Takes of Marine Mammals Incidental to Specified Activities; Taking Marine Mammals Incidental to Marine Site Characterization Surveys off of Massachusetts, Rhode Island, Connecticut, and New York

ACTION: Notice; issuance of an incidental harassment authorization.

Figure 1. Seasonally Restricted Areas

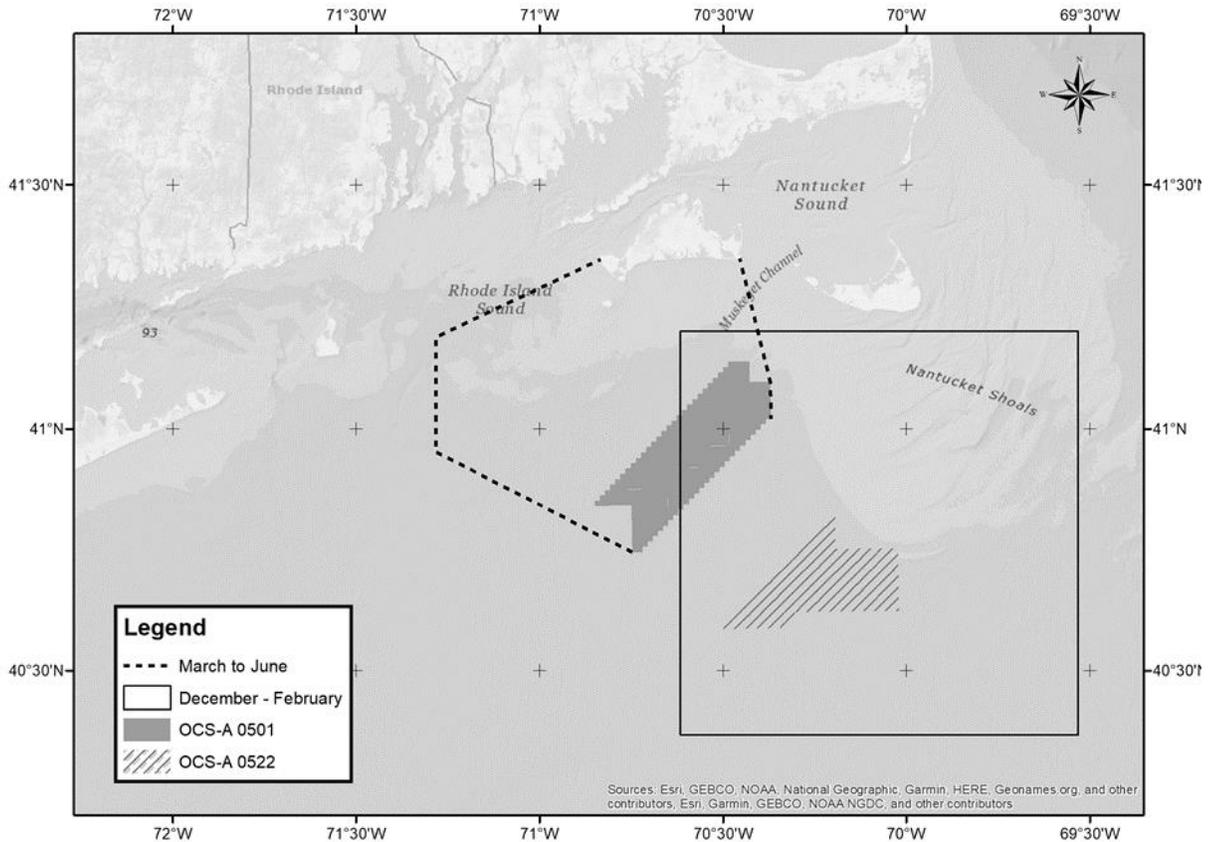
Comment 15: The ENGOs recommended a seasonal restriction on site assessment and characterization activities in the Project Areas with the potential to harass North Atlantic right whales between November 1, 2020 and May 14, 2021.

Vineyard Wind will conduct HRG survey activities in the Cape Cod Bay SMA and Off Race Point SMA only during the months of August and September to ensure sufficient buffer between the SMA restrictions (January to May 15) and known seasonal occurrence of the NARW north and northeast of Cape Cod (fall, winter, and spring). Vineyard Wind will also limit to three the number survey vessels that will operate concurrently from March through June within the lease areas (OCS-A 0501 and 0487) and OECC areas north of the lease areas up to, but not including, coastal and bay waters. The boundaries of this area are delineated by a polygon with the following vertices: 40.746 N 70.748 W; 40.953 N 71.284 W; 41.188 N 71.284 W; 41.348 N 70.835 W; 41.35 N 70.455 W; 41.097 N 70.372 W; and 41.021 N 70.37 W. This area is delineated by the dashed line shown in Figure 1. Another seasonal restriction area south of

Nantucket will be in effect from December to February in the area delineated by the DMA that was effective from January 31, 2020 through February 15, 2020. The winter seasonal restriction area is delineated by latitudes and longitudes of 41.183 N; 40.366 N; 69.533 W; and 70.616 W. This area is delineated by the solid line in Figure 1.

Vineyard Wind would operate no more than three survey vessels concurrently in the areas described above during the December-February and March-June timeframes when right whale densities are greatest. The seasonal restrictions described above will help to reduce both the number and intensity of right whale takes.
